GLEN ACRES SUBDIVISION, 1ST ADDITION, RESUBDIVISION OF LOTS 10 & 11, BLOCK "A"

The purpose of this application is to create a three-lot subdivision from two legal lots of records.

GLEN ACRES SUBDIVISION, 1ST ADDITION, RESUBDIVISION OF LOTS 10 & 11, BLOCK "A"

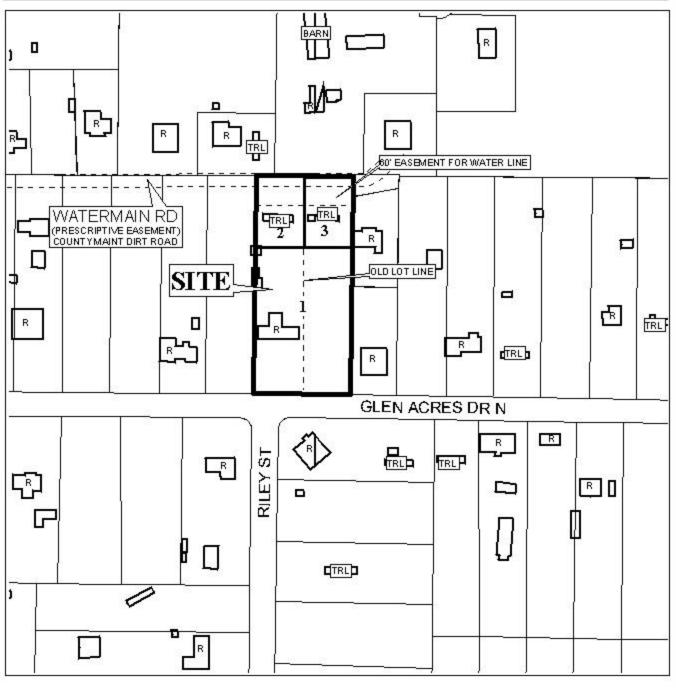
<u>Engineering Comments:</u> Must comply with the Mobile County Flood Damage Prevention Ordinance.

As illustrated on the plat, Lots 2 and 3 front Watermain Street, which is a prescriptive right-of-way connecting with Hubert Pierce Road. Based upon staff research the traveled roadway is no wider than 20' from Hubert Pierce Road to the site. This prescriptive right-of-way is essentially a dirt road that is graded frequently by the County. It is the practice of the Planning Commission to deny applications that would increase the number of lots on substandard (dirt) roads. This is to ensure adequate access, and to allow for future development of property. The current application would create two additional lots on a substandard (dirt) road. Additionally, the two existing lots access Glen Acres Drive North, which is paved; this application would create two new lots with a dirt road as the only access.

The 25-foot minimum setback line is not shown but would be required on the final plat.

Based upon the preceding, this application is recommended for denial for the following reasons: 1) the plat would increase the number of lots that access a substandard (dirt) road; and 2) the lack of access to a public street for Lots 2 and 3, as required by Section V.D.4. of the Subdivision Regulations.
